BID ADDENDUM NO. 1

Campbell-Savona Central School District
2020 Capital Project- Phase I
2450-035

Drawings issued by this Addendum:

AD1-A1 – MAIN OFFICE 100 – CURTAIN WALL TYPE
AD1-H1 – FIRST FLOOR HVAC PLAN – PARTIAL AREA B
AD1-T1 – COMMUNICATIONS TRENCH DETAIL

2 CURTAIN WALL TYPE CW-E
 1/4" = 1'-0"

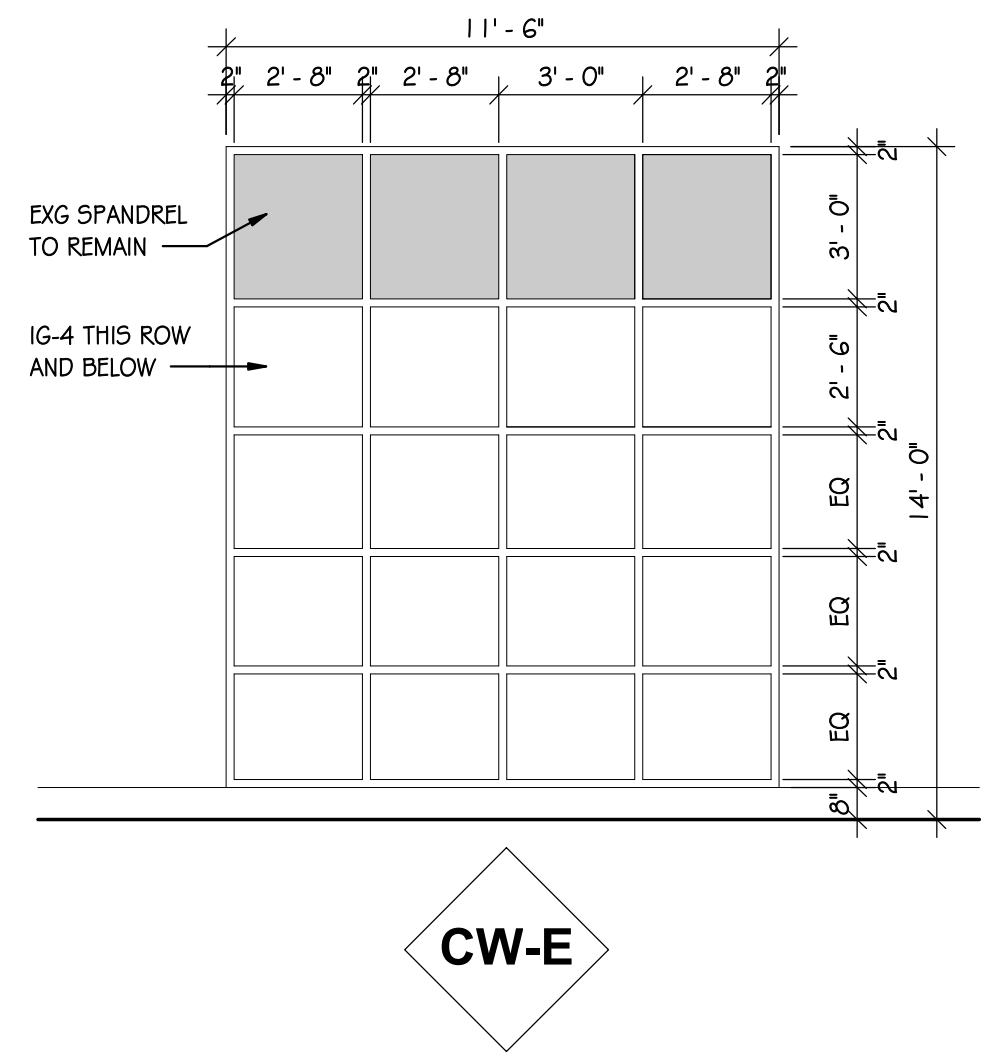
ITEM AD1-22 Refer to HS-A6.1 – WINDOW & DOOR SCHEUDLES

ADD Drawing AD1-A1 – Main Office 100 Curtain Wall Type, detail 2, issued by this addendum to Curtain Wall Types.

ITEM AD1-23 Refer to HS-A6.1 – WINDOW & DOOR SCHEUDLES

AMEND A6 Curtain Wall Schedule, with A6 Curtain Wall Schedule on drawing AD1-A1 Main Office 100 Curtain Wall Type, issued by this addendum.

1 FIRST FLOOR PLAN - MAIN OFFICE 100
 1/8" = 1'-0"

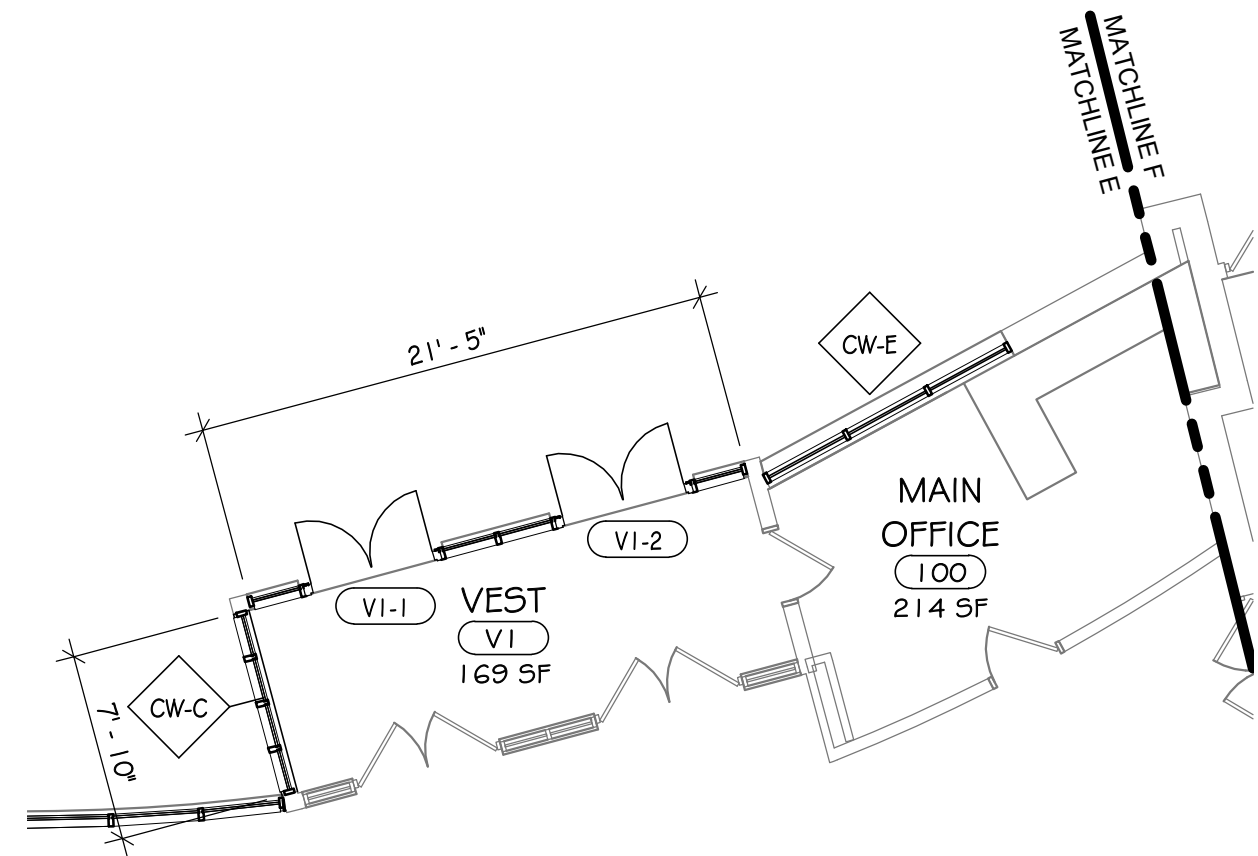
ITEM AD1-21 Refer to HS-A1.4 – FIRST FLOOR PLAN – AREA E

ADD Drawing AD1-A1 – Main Office 100 Curtain Wall Type, detail 1, issued by this addendum to detail 1.

1 FIRST FLOOR HVAC PLAN - PARTIAL AREA B
 1/8" = 1'-0"

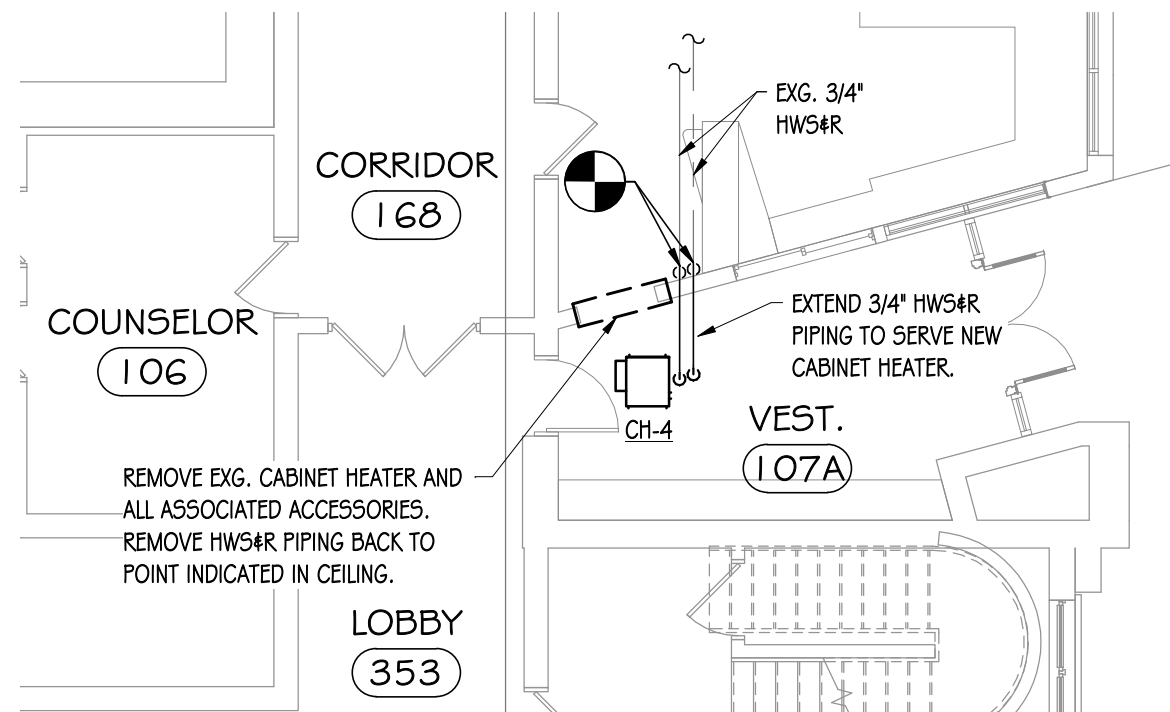
ITEM AD1-13 Refer to Drawing ES-H1.1 – KITCHEN PLAN – AREA C

ADD Drawing AD1-H1 - FIRST FLOOR HVAC PLAN – PARTIAL AREA B issued by this addendum.
